VAN'S AIRCRAFT, INC.

FF-1207 Cooling Shroud Modification

11-19-10

Figure 1: Remove Left Hand Induction Manifold

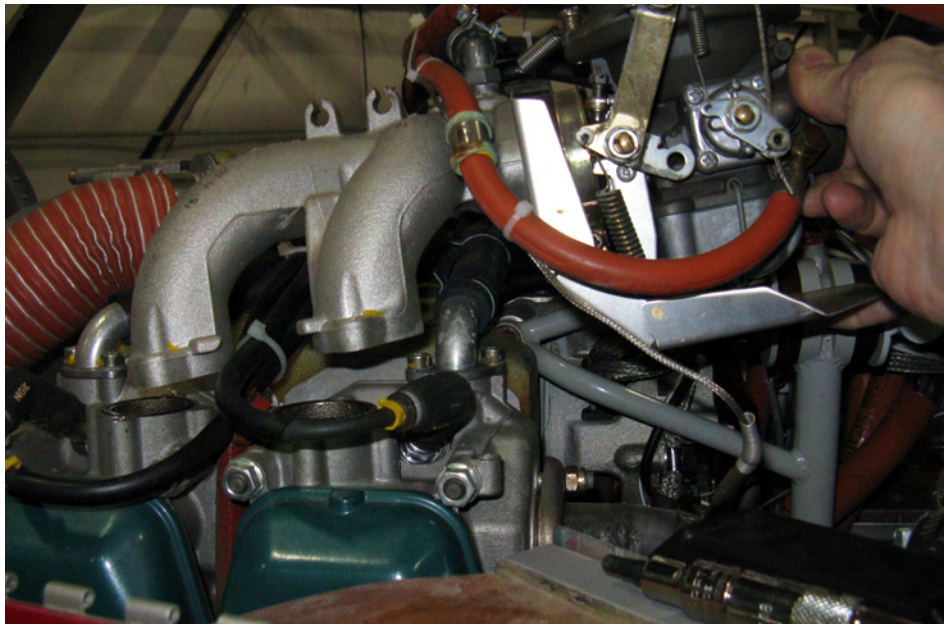
Step 1: Remove the Left Hand induction manifold from cylinders 2 & 4 by removing the 4 M6 Allen screws. See Figure 1.

Figure 3: Drill Cooling Shroud Cut-Out

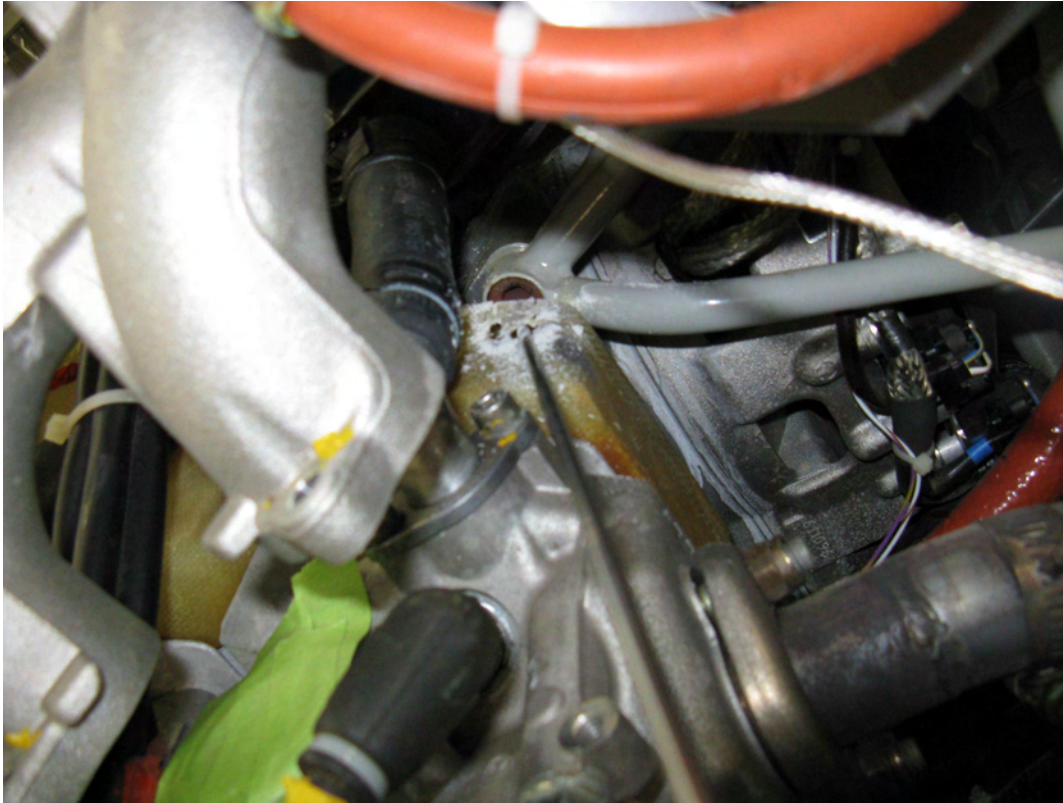
Step 4: Drill straight down along the outboard edge of the cut-out zone (use caution to only let the drill penetrate through the shroud no more than 1/4" or so to prevent hitting any part of the cyl.).

Now enter these holes from the left side (the manifold may be pulled up and out of the way), by tilting/angling the drill bit downward as you run the drill. Angle the drill so that the bit will exit the shroud near the bottom of the allen screw head. Drill a close pattern of several holes in the inboard end of the shroud approximating the arc of the screw head (sight down the length of the drill bit to approximate the exit point on the shroud). See Figure 3.

Figure 5: Cooling Shroud Cut-Out

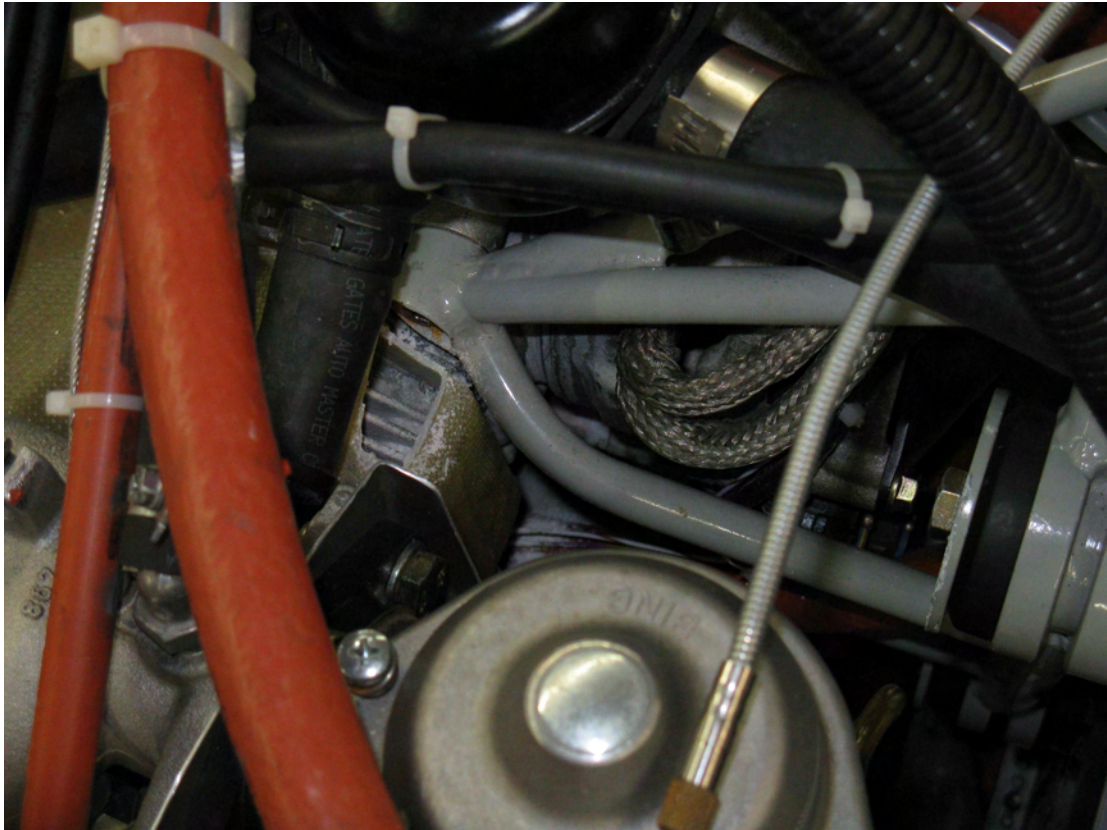
Step 6: Break out the remaining material using a needle nose pliers, and sand the edges smooth. (Sandpaper can be glued to / wrapped around a round object when finishing the shape of the opening). See Figures 5 and 6.

Figure 7: Fiberglass Cloth Lay-Up

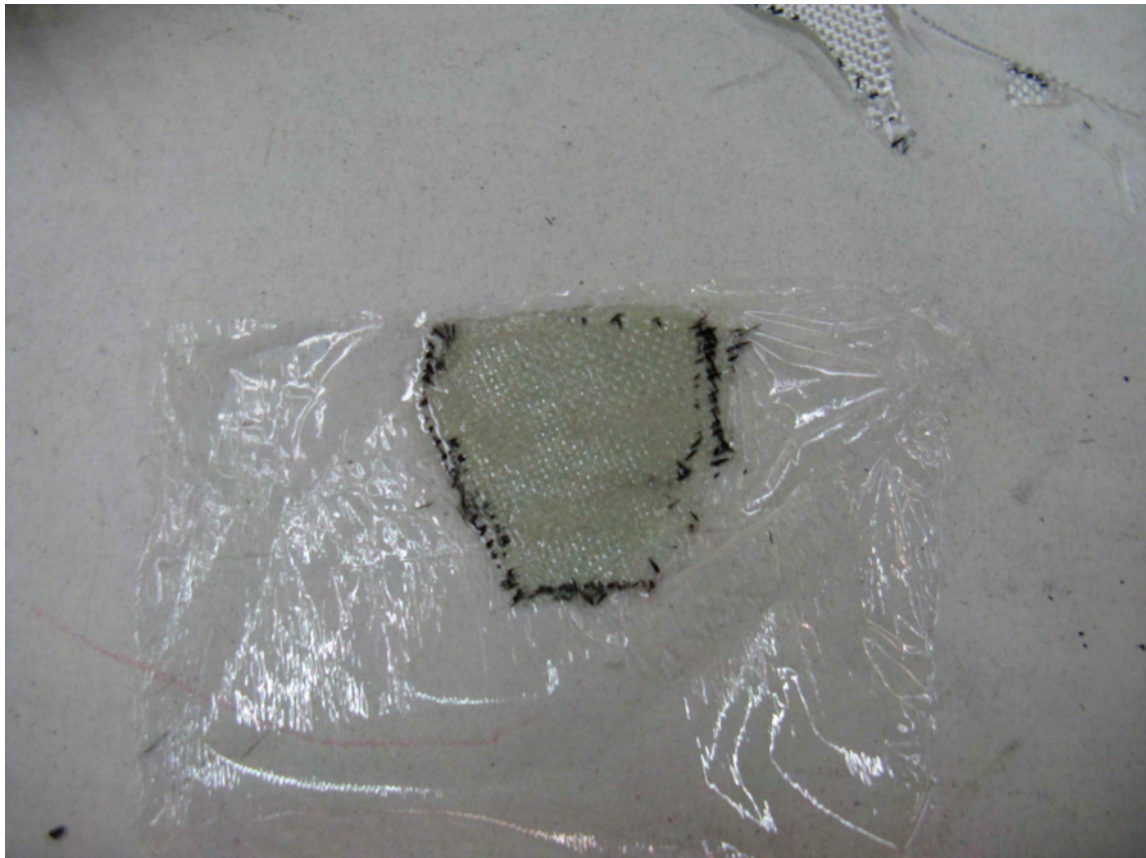
Step 9: Cut out two pieces of fiberglass cloth in a trapezoid shape, 2 inch base, 2 inches tall, 1.25" wide at the top. See Figure 7. Cut the fiberglass cloth such that the fibers are oriented approximately as shown in Figure 7.

Mix a small batch of epoxy resin, wet out and layer the fiberglass pieces on top of a 4" square of plastic food wrap (or similar) as shown in Figure 7.

Figure 8: Fiberglass Cloth In-Place on Cooling Shroud

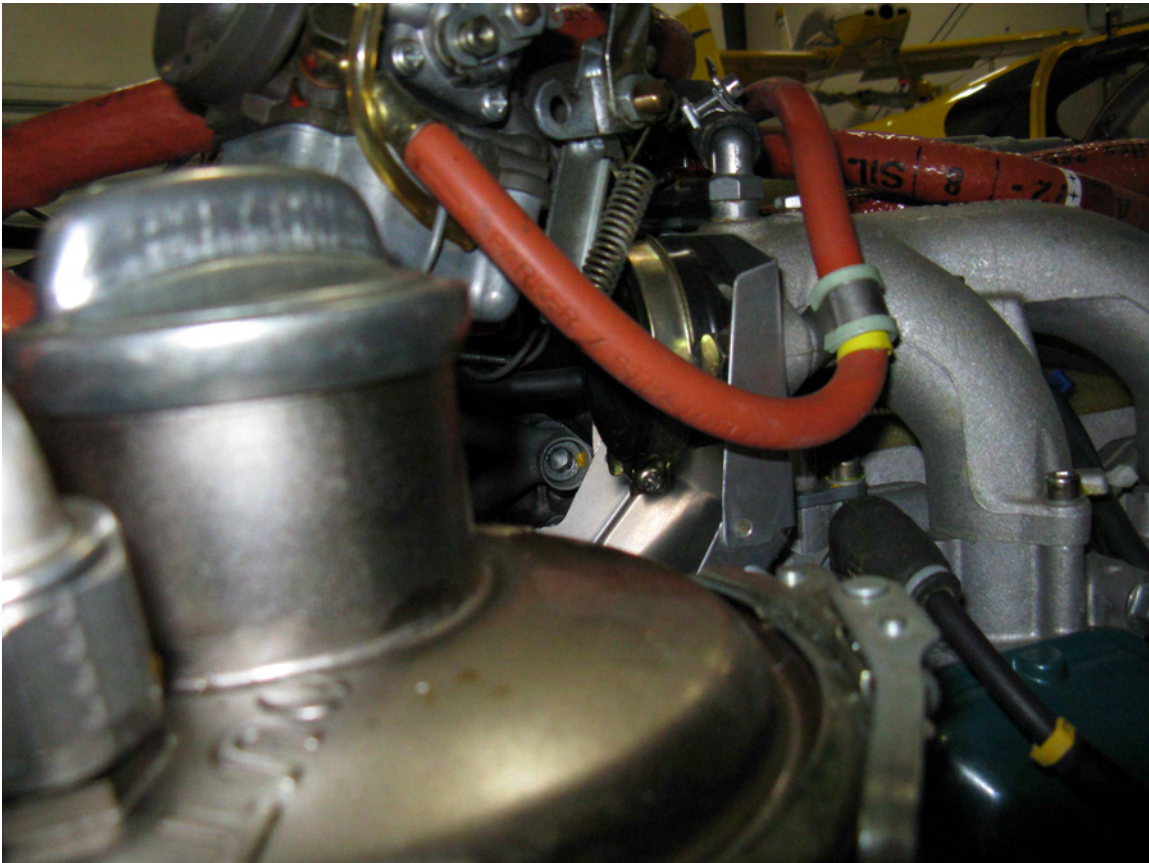
Step 10: Place the wetted-out fiberglass and plastic wrap over the hole in the shroud. With the plastic wrap still in place, insert the allen wrench into the engine mount allen screw to hold the cloth in place. Push the cloth edges down flat onto the shroud (you may need to use a small tool to smooth down the cloth on the inboard surface of the shroud, below the allen screw). See Figure 8.
